May 6, 2024

**RE: US Market Gas Station at 2115 Molalla Road (CU 24-01, DR 24-01, and ZA 24-01) Completeness Response**

RE: Status of CU 24-01, DR 24-01, & ZA 24-01 "US Market gas station" at 2115 Molalla Rd (Tax Lots 051W09B001000, 1100, & 1200 [primary])

**Figure 1: Queueing Area**

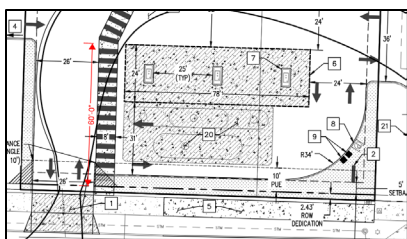
O. **Queueing:** *There appears too little room for vehicle queues at the pumps, and the application materials lack information about how queueing and circulation would operate. Guiding questions include:*

1. *Is queueing one way?*
2. *Are some pumps allocated for self-serve and others for attendant service or “mini serve”?*
3. *What signage and striping should the site plans illustrate and note to describe intended queueing?*
4. *How is queueing handled in the field during operations?*
5. *What would prevent queued vehicles from backing up onto the highway?*
6. *Because the site plan indicates no attendant booth, where and how would the attendant(s) be stationed?*

*The response doesn't address the item and guiding questions, particularly Question 3.*

- Response:** The following responses address staff's guiding questions regarding queuing space. They confirm that the site has sufficient queuing room to accommodate the needs of a small-scale gas station.

1. *Is queuing one-way?* Unlike gas stations with multiple rows of pump islands, where one-way queuing is often implemented to manage traffic flow, the single row of pumps doesn't require this control. Vehicles can enter the site from either Molalla Road or the Woodburn Eastside Apartments entrance, allowing for more flexible queuing arrangements.

2. *Are some pumps allocated for self-serve and others for attendant service or "mini serve"?* Pumps will be allocated for self-serve and attendant service in accordance with current State regulations. Gas stations in Marion County currently allow up to 50 percent of fuel pumps to be allocated for self-serve.

3. *What signage and striping should the site plans illustrate and note to describe intended queueing?* As previously stated, this project involves the construction of a small-scale gas station. Typically, such establishments do not require excessive dedicated queuing space or specified directional signage and striping due to the specific characteristics of their operations and customer behavior. In contrast to larger discount or membership-based gas stations like Fred Meyer and Costco, where lengthy queues are common and multiple lanes of pump islands are provided to accommodate high customer volumes, smaller gas stations generally cater to localized customers with lower traffic volumes resulting from pass-by trips. Customers at small gas stations are inclined to stop only if they perceive that their wait will be brief, thereby minimizing the need for extensive queuing areas. No queuing concerns are anticipated which would necessitate directional signage and striping for the single row of fuel pump islands. Furthermore, directional striping is provided on site as indicated on the site plan in Attachment 1.

4. *How is queueing handled in the field during operations?* Queueing will be managed by the layout of the gas station itself. The single row of pumps and the designated entry and exit points will guide drivers on how to line up.

5. *What would prevent queued vehicles from backing up onto the highway?* As previously stated, this project involves the construction of a small-scale gas station. Typically, such establishments do not require excessive dedicated queuing space due to the specific characteristics of their operations and customer behavior. In contrast to larger discount or membership-based gas stations like Fred Meyer and Costco, where lengthy queues are common due to high customer volumes and competitive pricing, smaller gas stations generally cater to a more localized customers with lower traffic volumes resulting from pass-by trips. Customers at small gas stations are inclined to stop only if they perceive that their wait will be brief, thereby minimizing the need for extensive queuing areas and reducing the risk of vehicles backing up onto the highway.

6. *Because the site plan indicates no attendant booth, where and how would the attendant(s) be stationed? Attendant locations will shift between pumps and the convenience store based on demand.*

**C100**

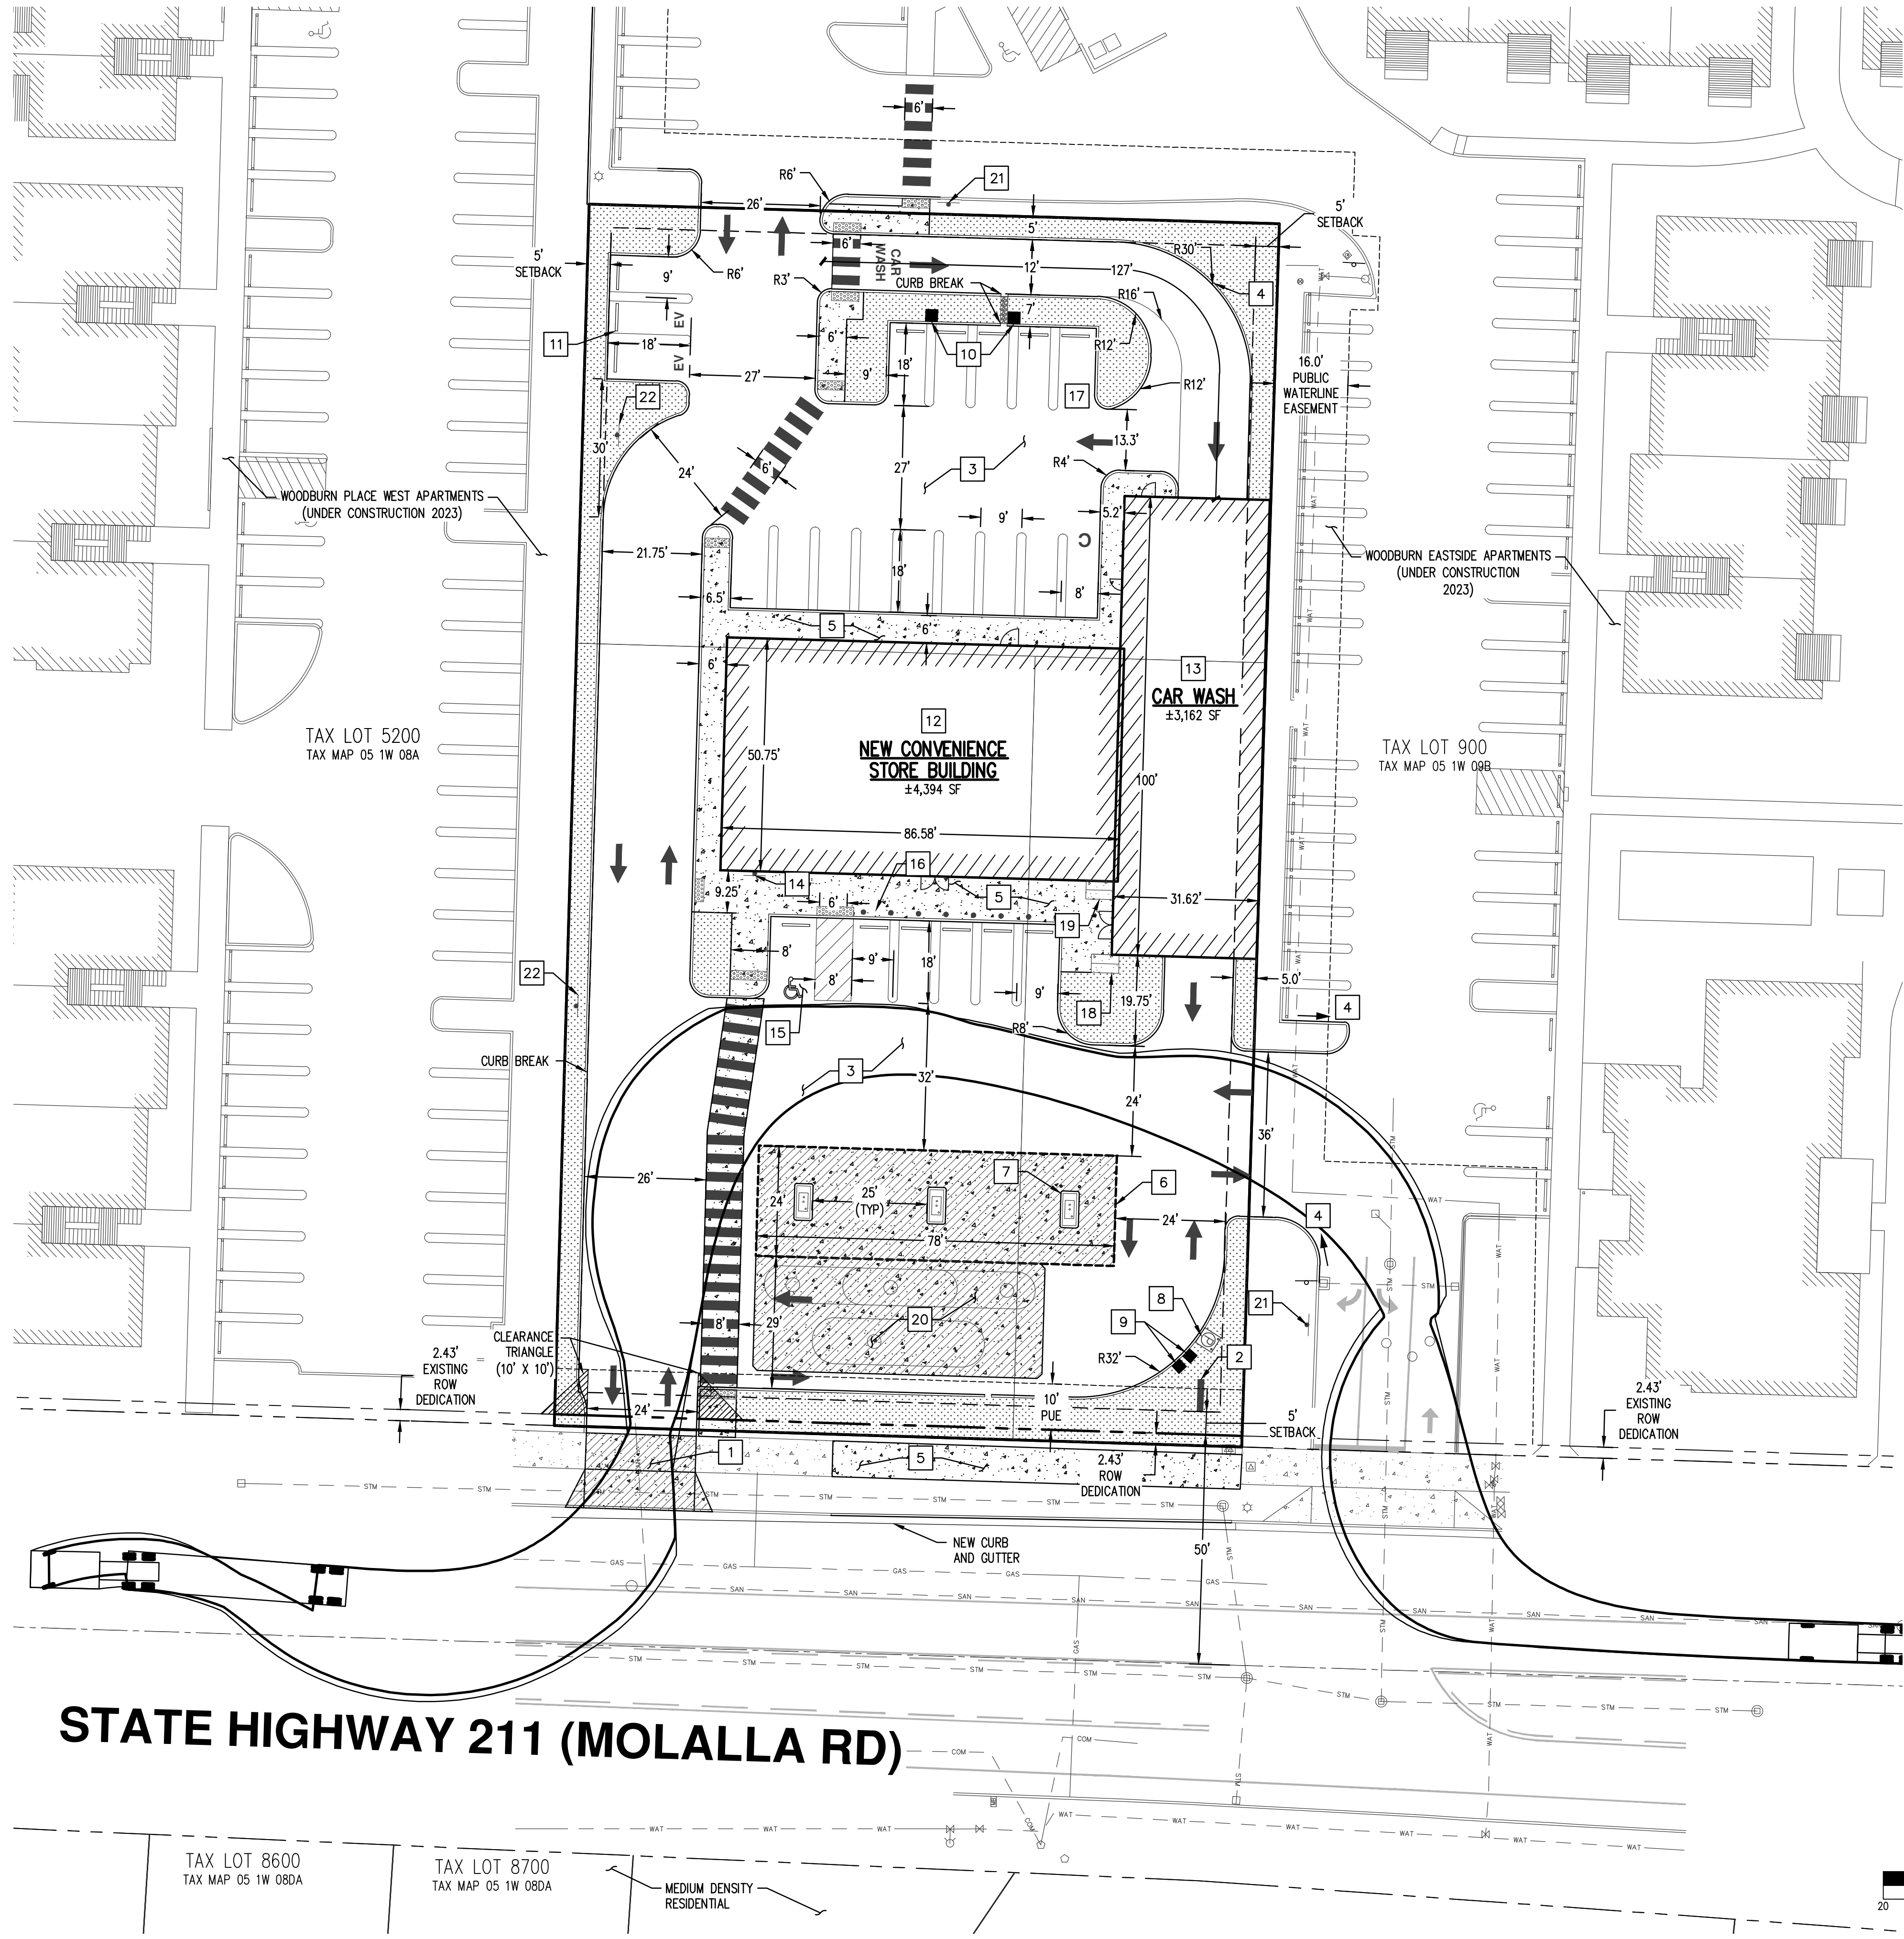
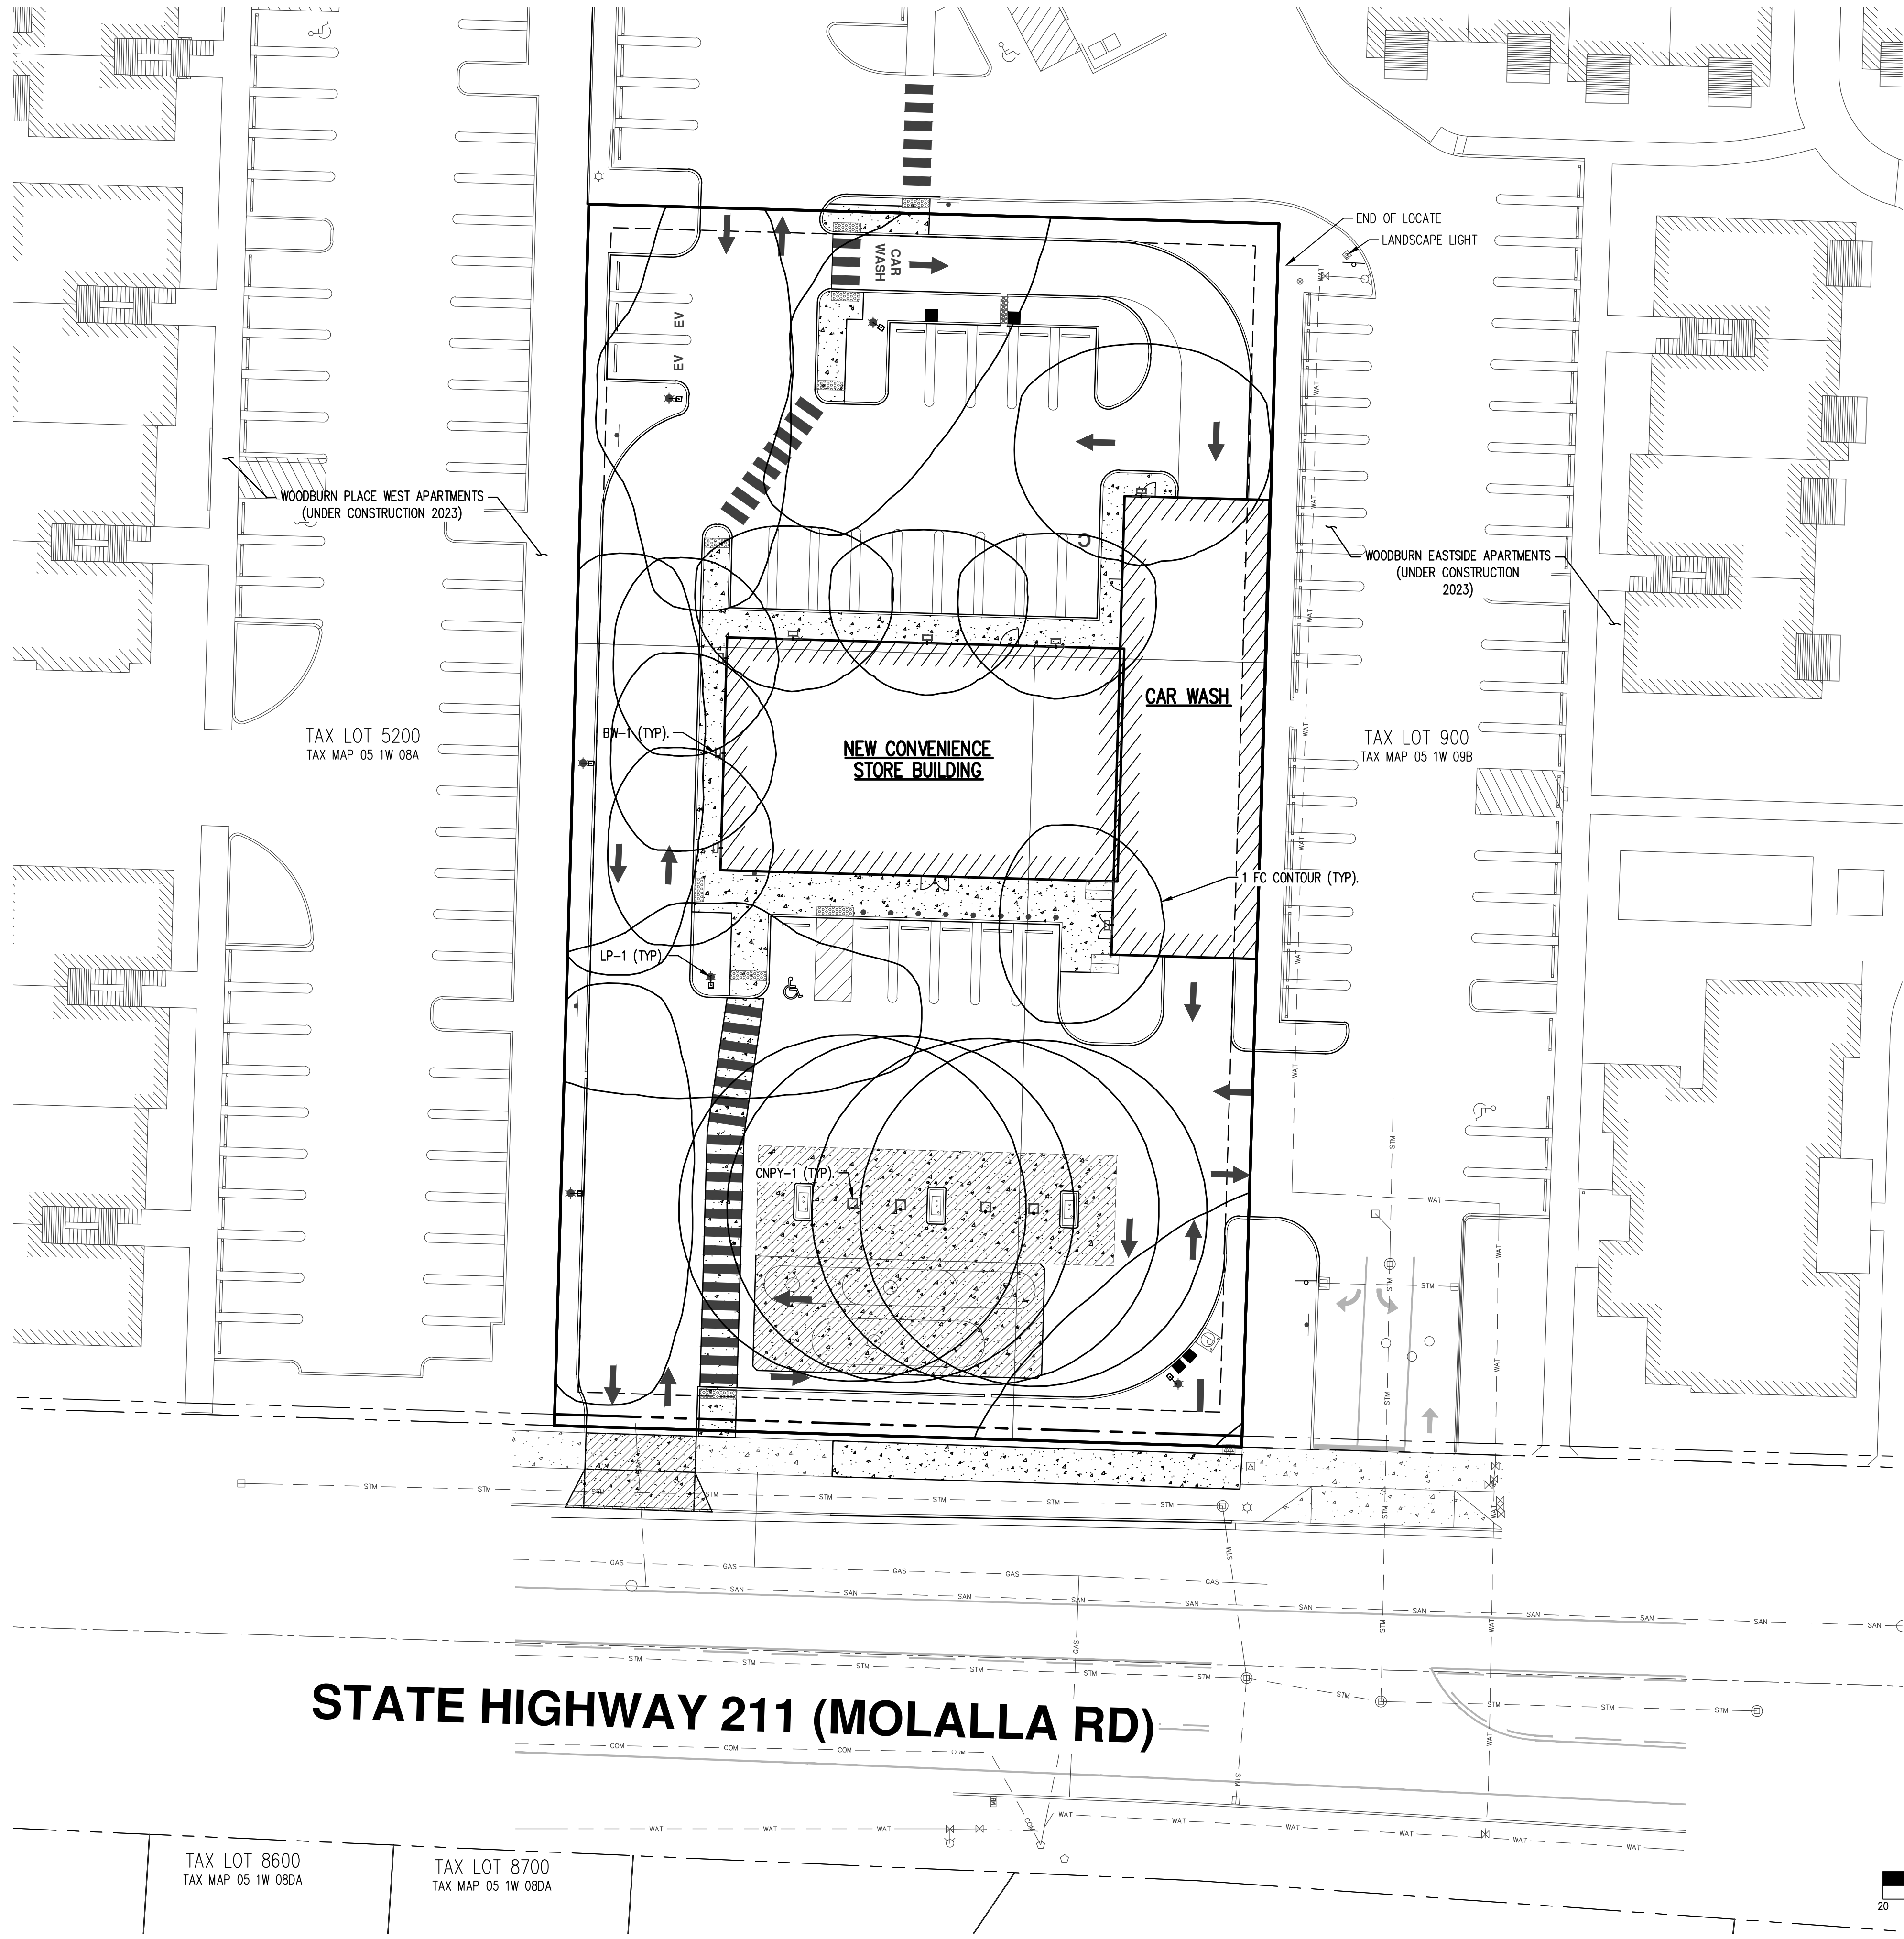
**D. Driveway: Regarding the proposed driveway at 26 feet width:**

1. *Submit Woodburn Fire District documentation allowing the developer to make use of Table 3.04A footnote 7 and revise the narrative under 3.04.04 to refer to the documentation.*

*The site plan (Sheet C100) illustrates turning movement that doesn't need 26 ft of width, and in any case the description above doesn't affect the applicability of the WDO standard.*

*Note: Zoning Adjustment (ZA) of maximum driveway width to 26 ft is permissible per 5.02.06C.19c – with a ZA application including a revised uniform application form, ZA fee payment of \$3,520 per the Planning Division fee schedule, and application materials that address the factors and meet the criteria of 5.02.06B; however, staff doesn't see how a proposal could meet criteria 1, 3, & 5 and would be disinclined to recommend approval.*

*Revise the site plans (or apply for ZA).*

- I. **Walkway islands/peninsulas:** *To conform with 3.06.03C.4, revise the site and landscape plans to provide a landscaped island or peninsula along the west side of the wide walkway where it passes through the parking aisle at the convenience store. (Revision could change the walkway alignment.)*

*The description above doesn't affect the applicability of the WDO standard.*

*Revise the site plans (or apply for a variance).*

**Response:** The Preliminary Site Plan has been revised as requested above. Refer to Sheet C100 in the revised Preliminary Land Use Plans in Attachment 1. This item is complete.

**Response:** The Preliminary Site Plan has been revised as requested above. Refer to Sheet C100 in the revised Preliminary Land Use Plans in Attachment 1. This item is complete.

Please note: Due to the rearrangement of the walkway abutting the landscape peninsula, one vehicle parking space was lost along the convenience store frontage. To compensate for this loss, a new vehicle parking space was added next to the EV parking spaces in the northwest corner of the site. The front yard was also increased to account for the landscaping removed to create the new parking space, thus maintaining the required minimum 20 percent of landscape area.
